Hillingdon

Outline Fire Strategy – Rev E

OF-OFS-3671-01-E

Appendix A – Drawing Comments

1 Building 9 - Ground Floor Plan
1 : 200

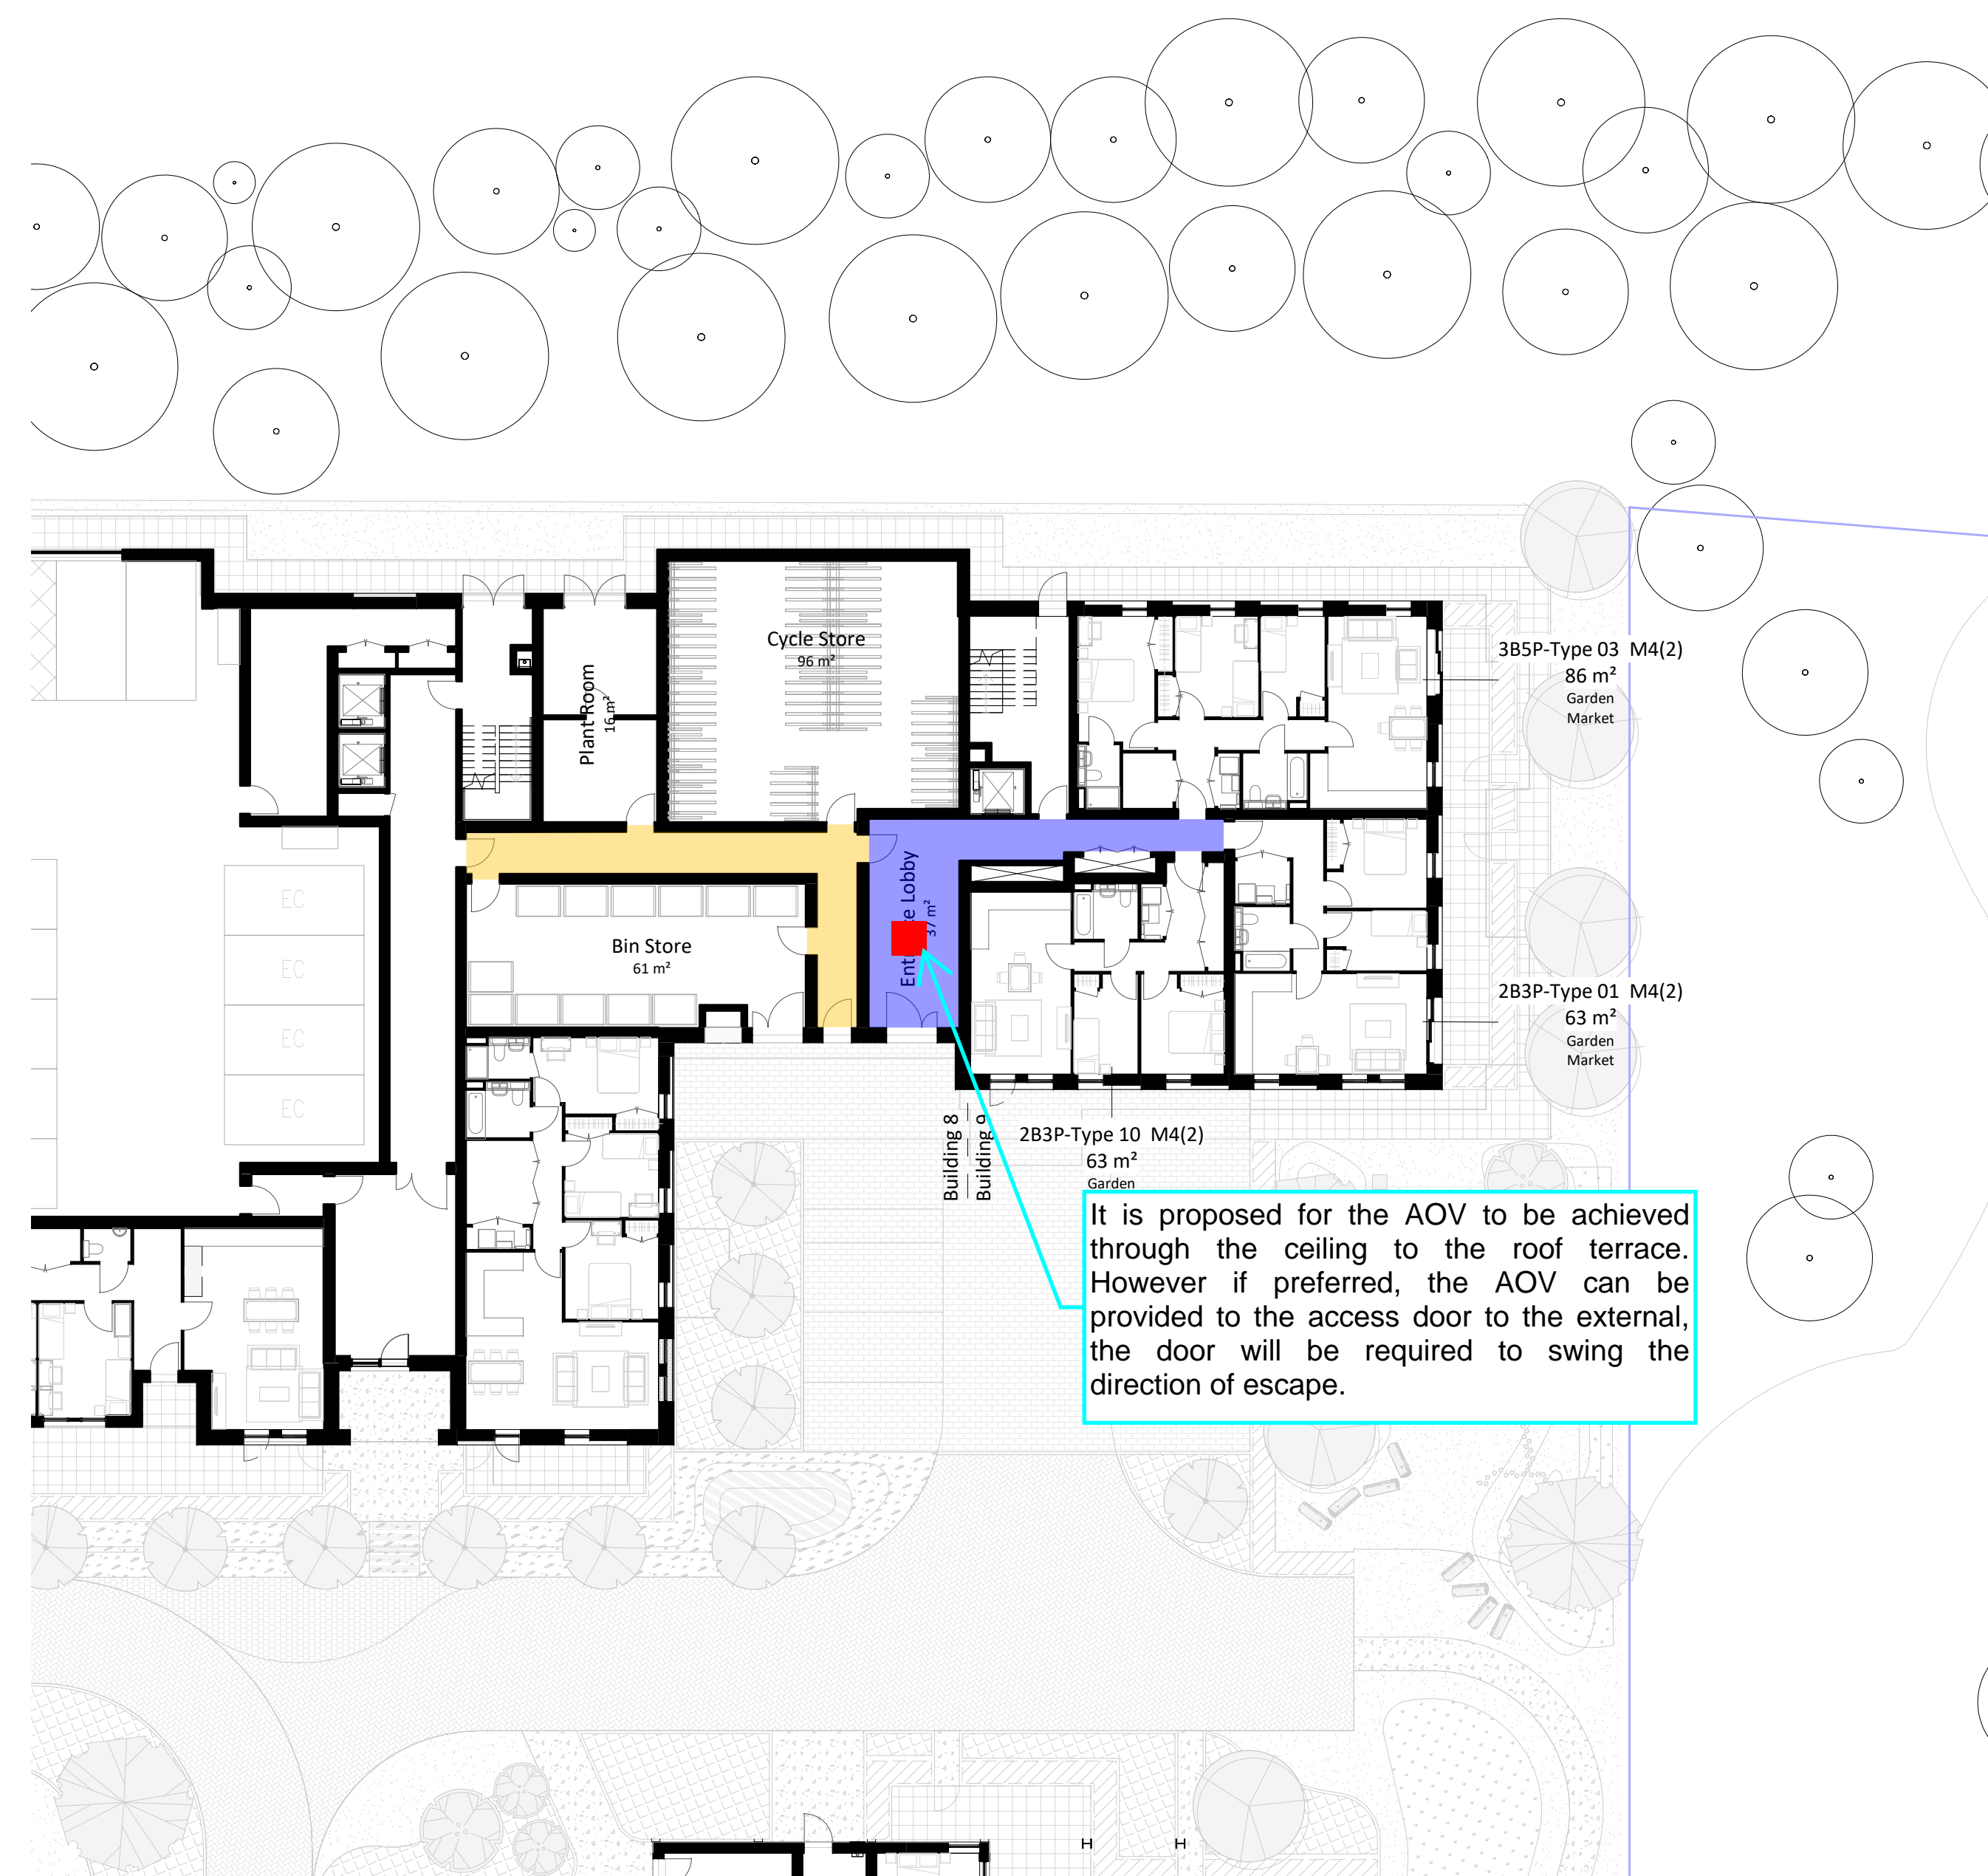
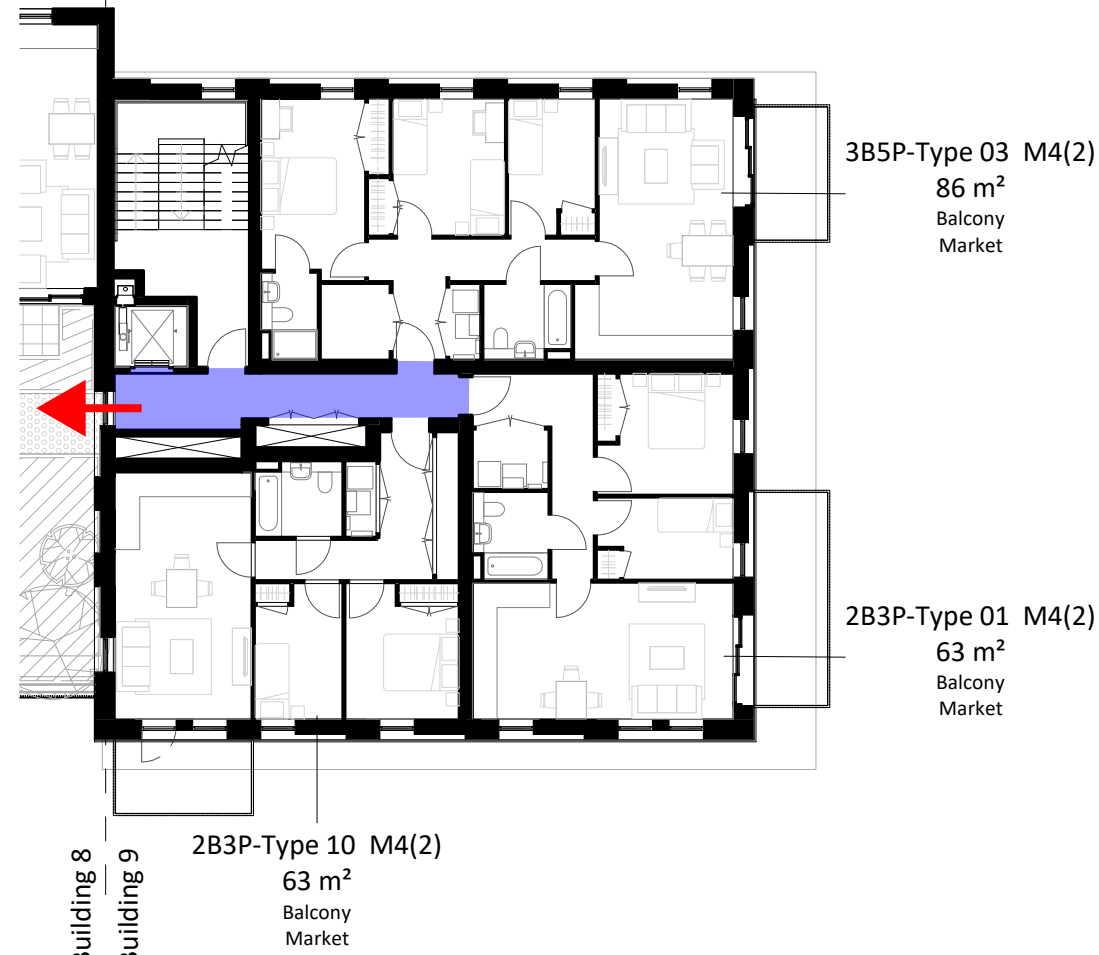
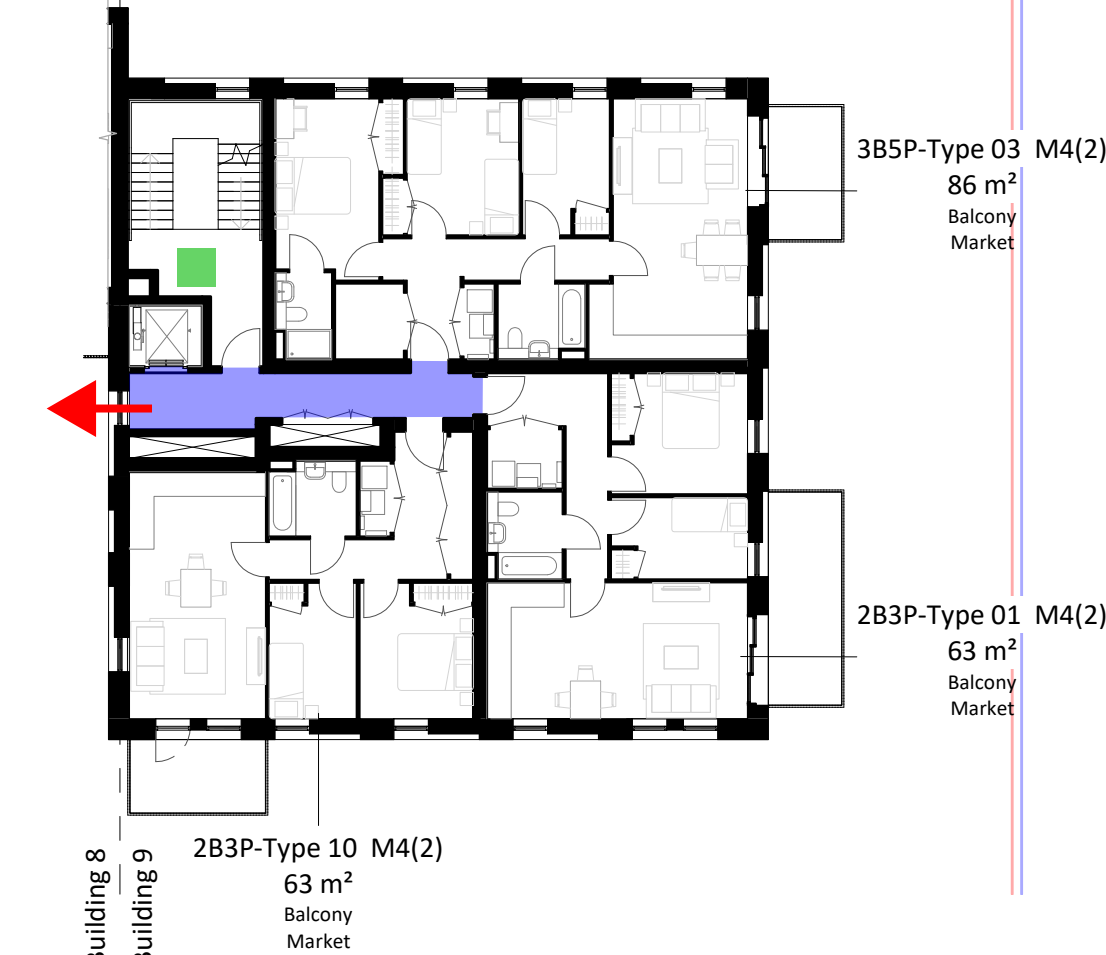
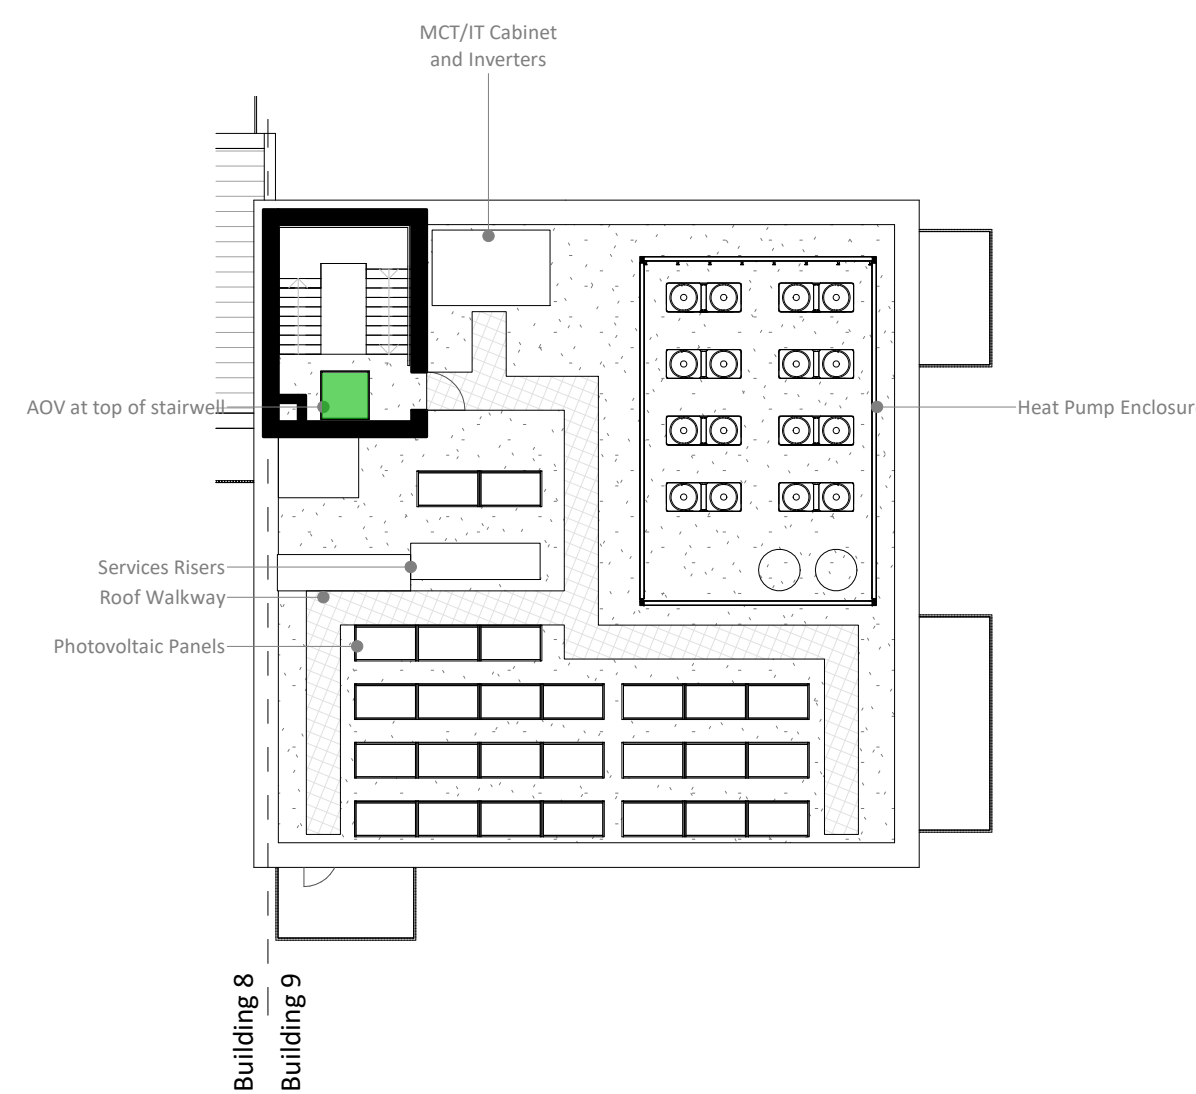
It is proposed for the AOV to be achieved through the ceiling to the roof terrace. However if preferred, the AOV can be provided to the access door to the external, the door will be required to swing the direction of escape.

To be noted, the government have stated from May 2020, all new building's over 11m in height are required to be provided with sprinklers, see Section 9.

To be noted, if the service riser is to only contain water services or metal ventilation ductwork from the ground floor, it is considered a limited fire hazard. As such, this riser shaft may be located in the staircase lobby.
